Application for Licence

Licence Number	L9329/2022/1
Applicant	Penny Operations Pty LTD
ACN	618 514 944
File number	DER2021/000704
Premises	Penny Gold Project M57/180 and M57/196 Sandstone Shire
Date of report	1 July 2022
Decision	Licence granted

Figure 1: Premises layout

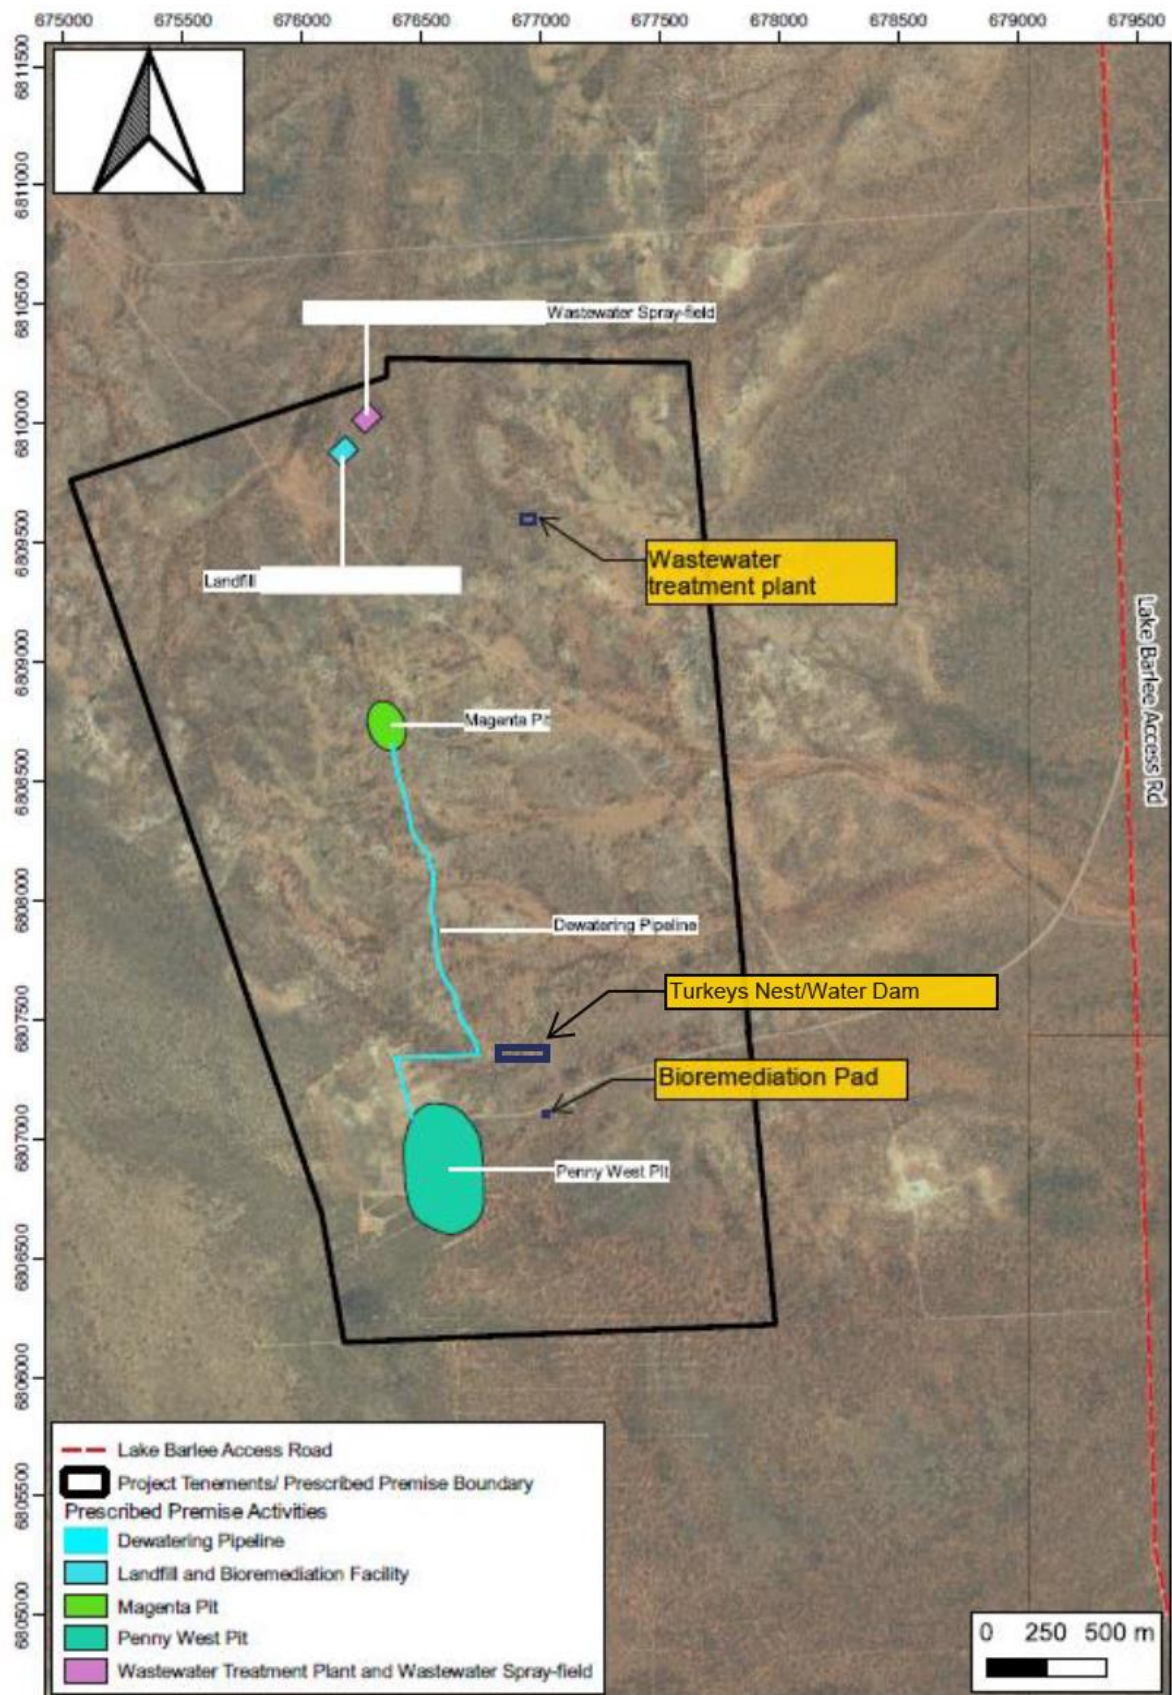
DWER Request	Summary of applicant's comment	Department's response
Applicant to provide updated figure 1 to include turkey nest location (condition 1: Table 1 – Turkey nest)	Figure 1 at the end of this document is now updated.	Acknowledged and new map showing the location of the turkeys nest added to licence and decision report.
Applicant to confirm whether phase 1 has been completed	Phase 1 completed	Acknowledged and decision report updated.
Applicant to confirm status of remaining dewatering requirements below: The total remaining dewatering requirement at the Premises is as follows: • Current existing Penny West pit lake water storage of approximately 250,000 kL; • Penny West and Penny North groundwater storage of approximately 500,000 kL; and • Ongoing groundwater inflow of approximately 100 kL/day, increasing to a maximum of 500 kL/day as underground development progresses.	Current existing Penny West pit lake water storage of approximately 250,000 kL completed, no further dewatering required. Penny West and Penny North groundwater storage of approximately 500,000 kL confirmed. Ongoing groundwater inflow of approximately 100 kL/day, increasing to a maximum of 500 526 kL/day as underground development progresses.	Acknowledged and decision report updated.

Figure 3: Distance to sensitive receptors

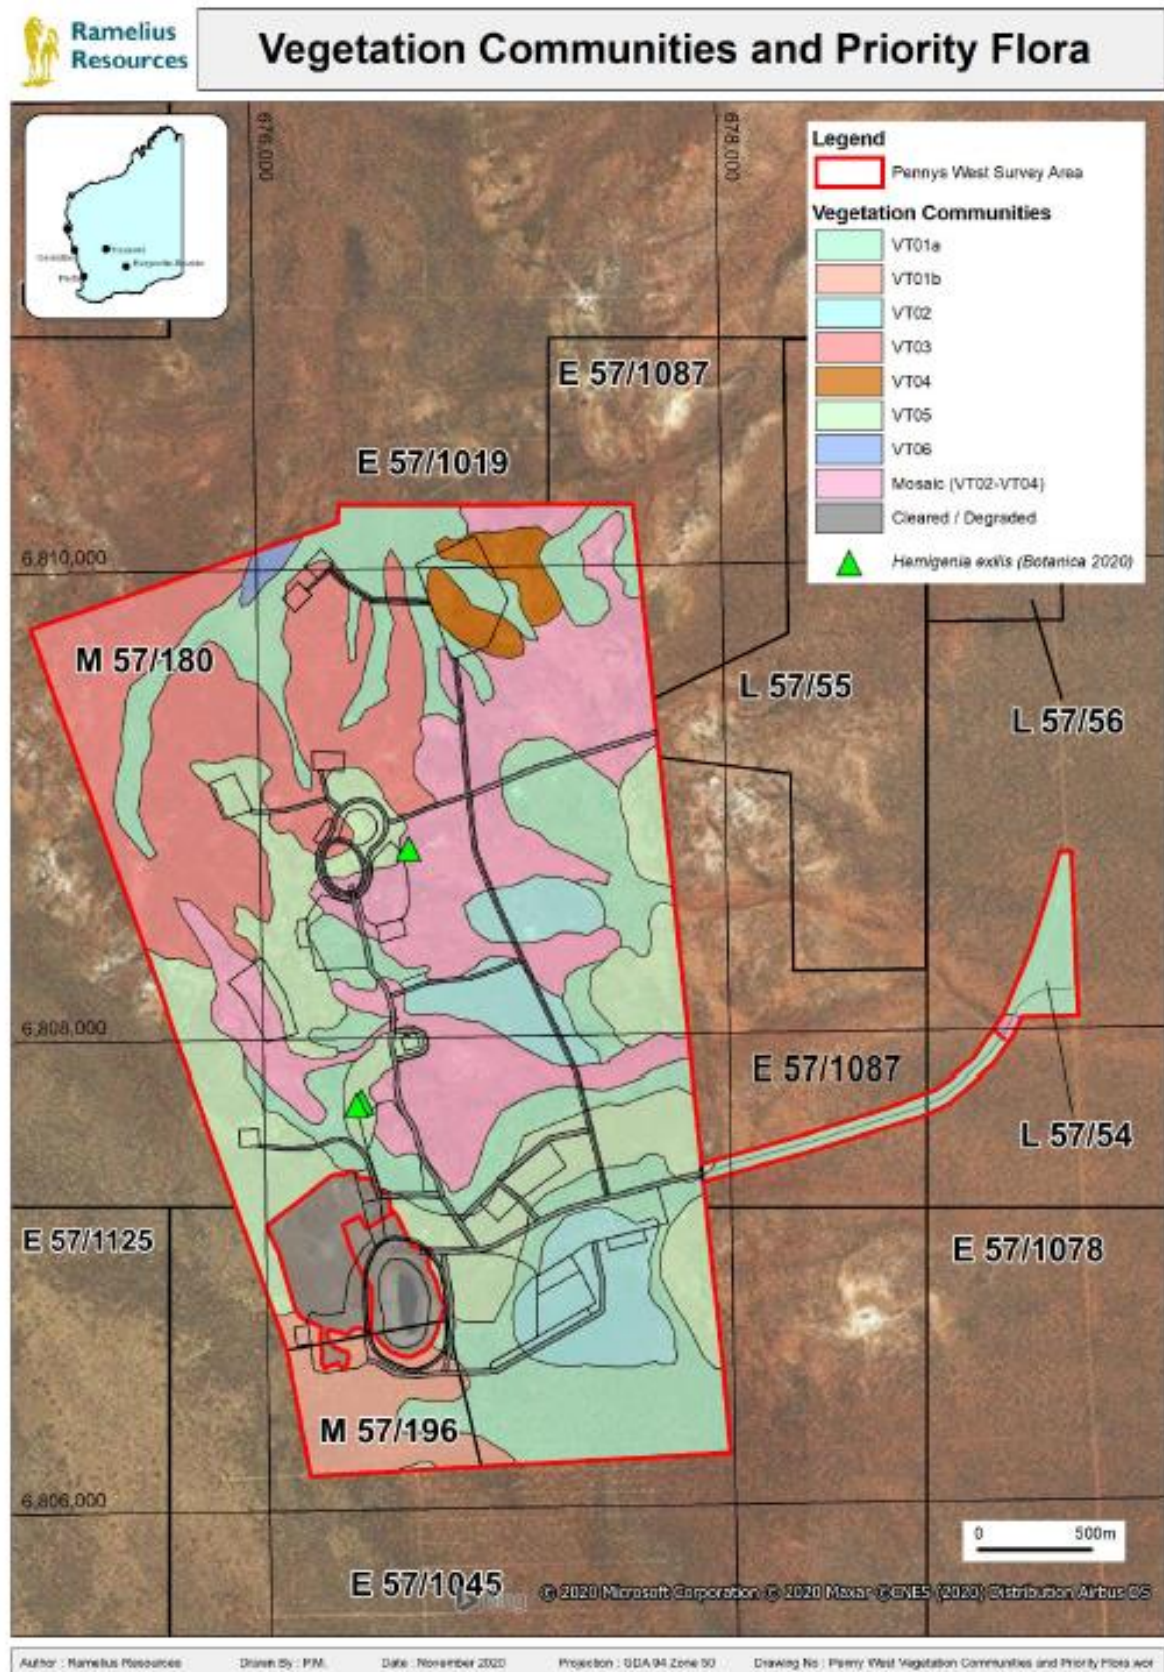
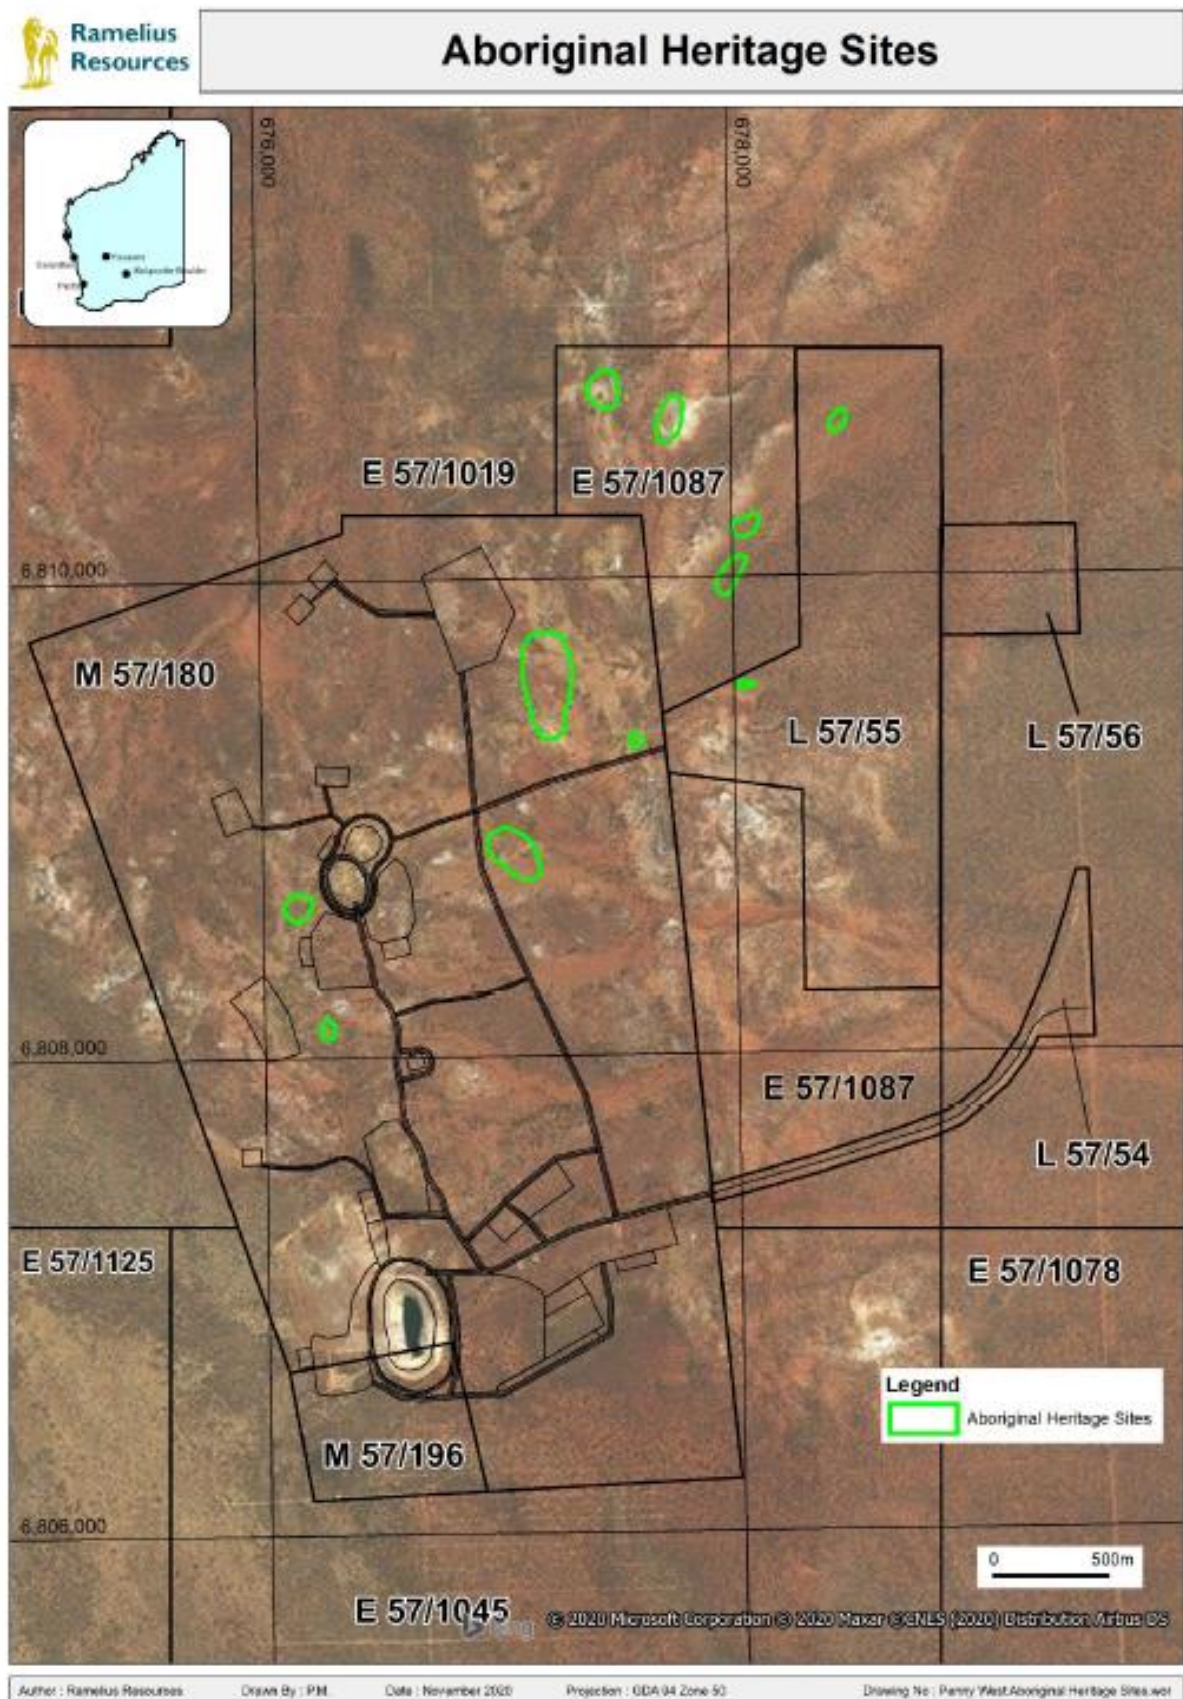
DWER Request	Summary of applicant's comment	Department's response
<p>Applicant to provide updated Figure 3 showing location of existing turkey nest. Applicant to provide turkey nest's specifications (liner used, dimensions, management and operational freeboard/ designed to contain 1:100 year rainfall events?).</p>	<p>Two cells both 80m (L) x 80m (W) x 3m (H). First cell is the disposition cell maintained at ~0.4m freeboard. This cell has a spillway into second cell in which water is pumped out to underground or to the standpipe. Second cell maintained at ~1.0m freeboard.</p> <p>The liner is HDPE, 1.5mm thick, installed and buried into top of wall. Contains 4 animal egress mats. Around the base of the dam, a 900mm high stock fence has been installed with 2 sets of driveable width gates.</p>	<p>Acknowledged. Table 3: Proposed applicant controls of the decision report updated.</p>
